## SERVICE LETTER 216

### Cessna 208 Caravan 8000A & 8750A Hydraulic Pump Replacement

<b>Aircraft Makes/Model(s):</b>	<b>Float Model(s):</b>	<b>Compliance:</b> Optional	<b>By:</b> MAS
Textron Aviation 208	8000A & 8750A	<b>Part Number:</b> 1011602	<b>Approved:</b> DRH
		<b>Date:</b> 4/29/2024	<b>Revision:</b> C

**DISCONTINUED**  
**HYDRAULIC PUMP 8A09000-031**

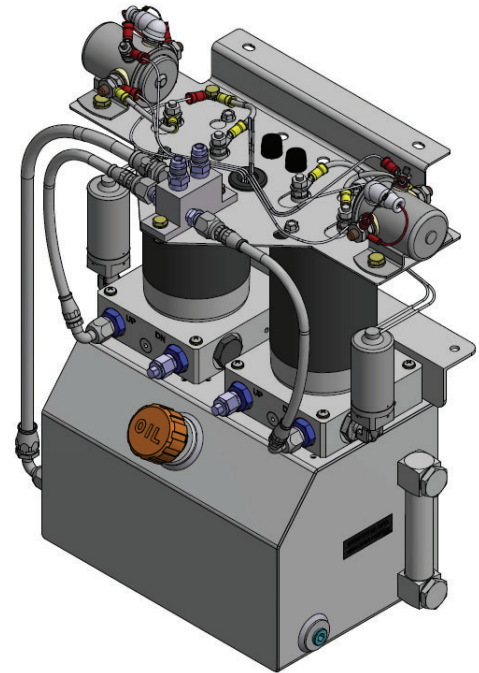
Hydraulic Pump Assembly p/n 8A09000-031 has been discontinued. This service letter provides the option to replace it with a new pump p/n 1011404.

**NEW**  
**HYDRAULIC PUMP 1011404**

**SOLENOID SCHEMATIC**

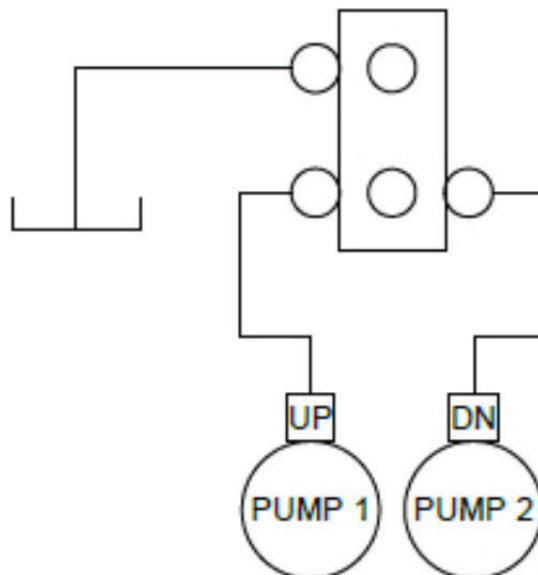
1. Pull Pump 1 and Pump 2 circuit breakers.
2. Remove and cap both pressure and return hydraulic lines on hydraulic pump manifold 6A09000-027.
3. Remove GA1 and GA4 wires (12 ga) from electrical solenoids on hydraulic power pack 8A09000-031.

**HYDRAULIC SCHEMATIC**

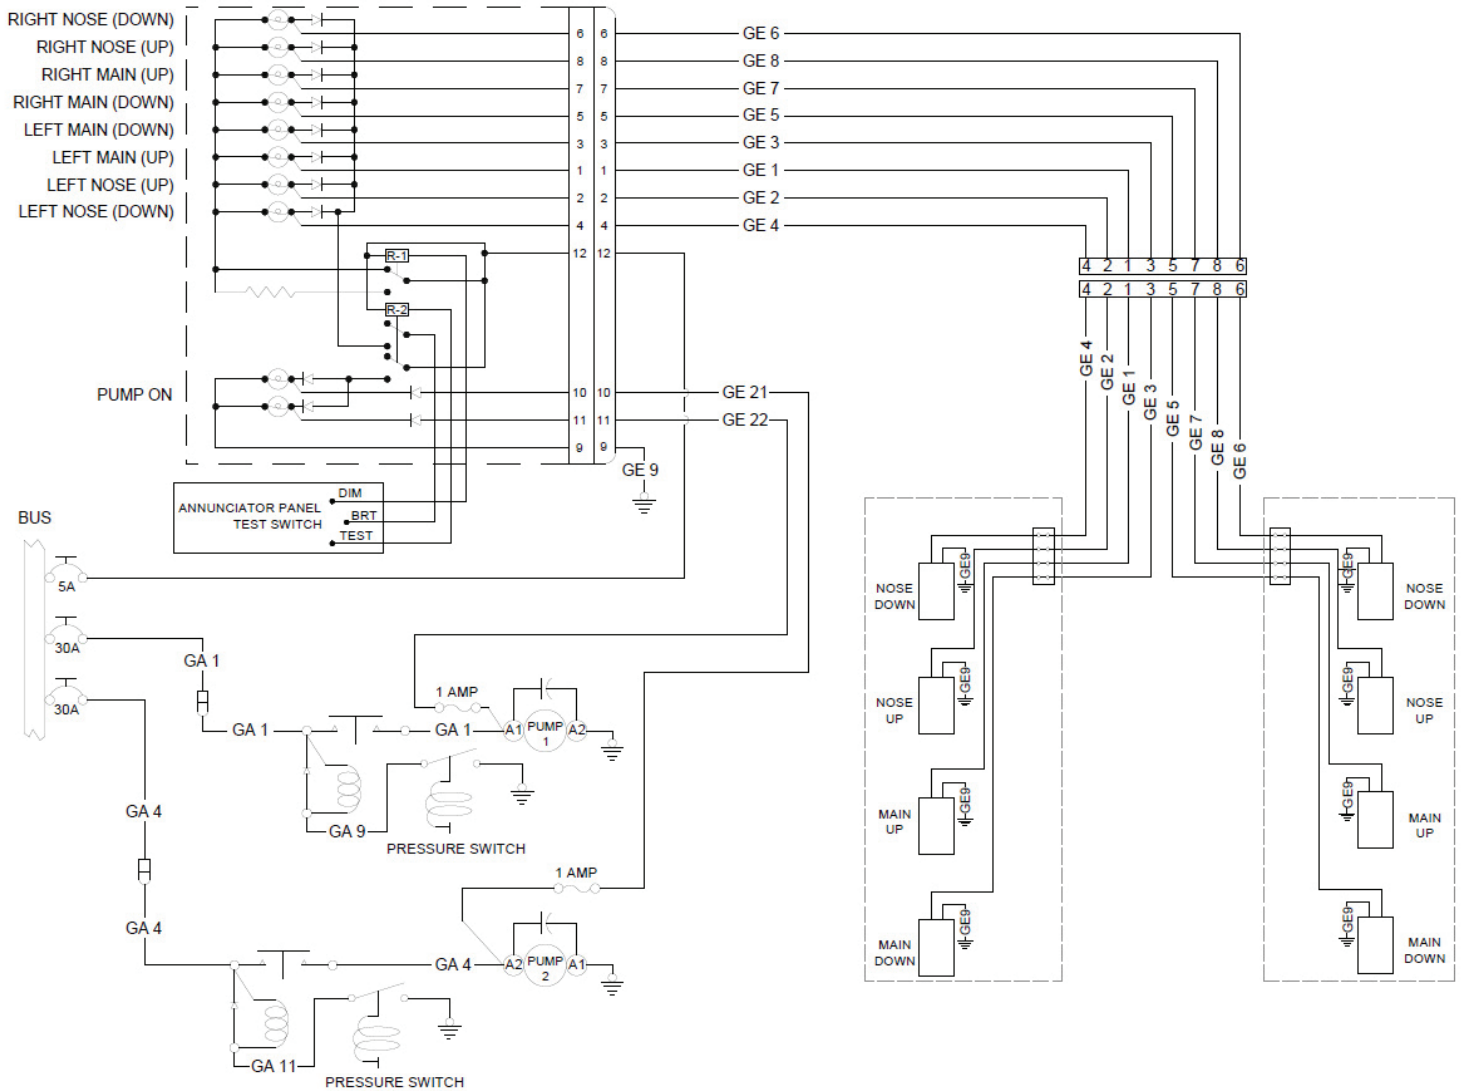
4. Cut GE10 and GE11 wires (20 ga) at butt splice connection. If aircraft has G1000 avionics, cut GE21 and GE22 (20 ga) wires.
5. Unbolt and remove hydraulic power pack 8A09000-031 from pump mount assembly.
6. Install new hydraulic power pack 1011404 onto pump mount assembly using existing hardware.
7. Install pressure and return line to hydraulic pump manifold. Refer to hydraulic schematic.

**ELECTRICAL SCHEMATIC (G1000 EQUIPPED AIRCRAFT)**

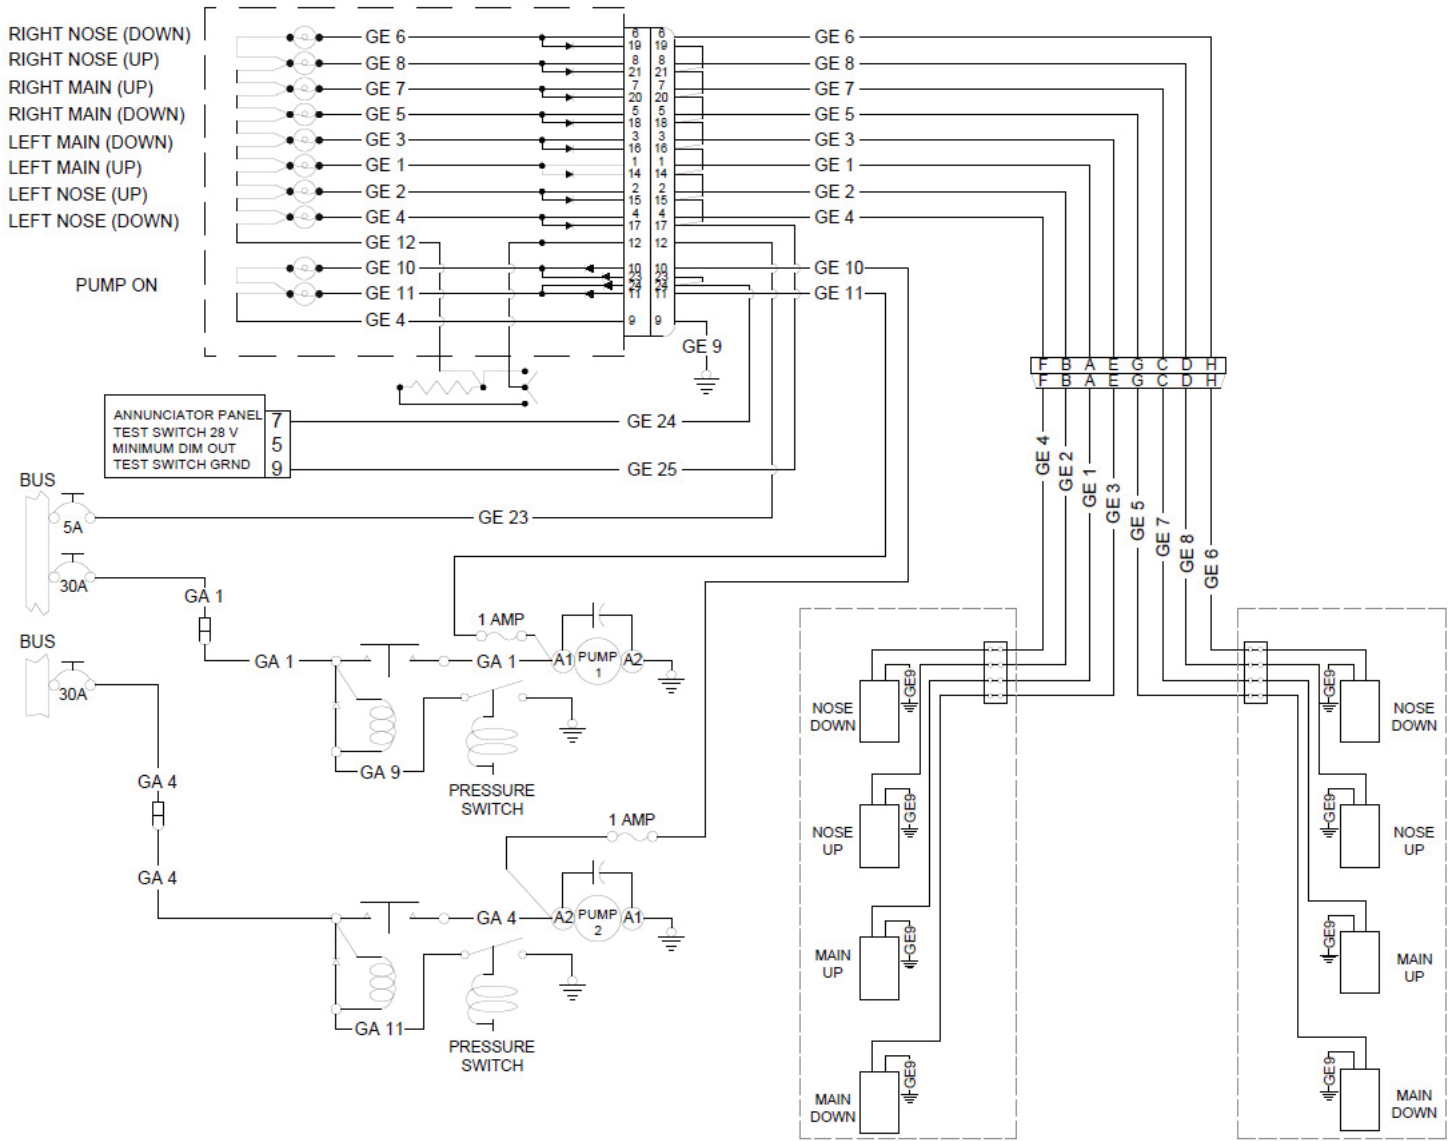
8. Re-install GE10 and GE11 wires (20 ga), or GE21 and GE22 for G1000 equip aircraft, onto wires coming from fuse holder with supplied butt splice connectors. See electrical schematic.
